Access Compliance Report Public Rights-of-Way (Pedestrian Signals)

Main Street: FAIRHAVEN_AVE Cross Street: PROSPECT_ST Location: NW

ADA ID: SGAT211022103442 Signal Type: One Push Button-Non APS Overall Compliance: No Severity Scores: BTN 1: 35 BTN 2: N/A No BTN: N/A

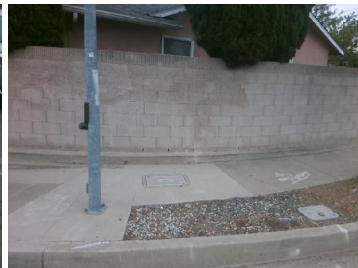
OC Std/PROW: R404.2, R404.3, MUTCD 4e.08

Possible Solutions: Replace Signal Push Button With APS Button. Remove and Replace Clear Space.
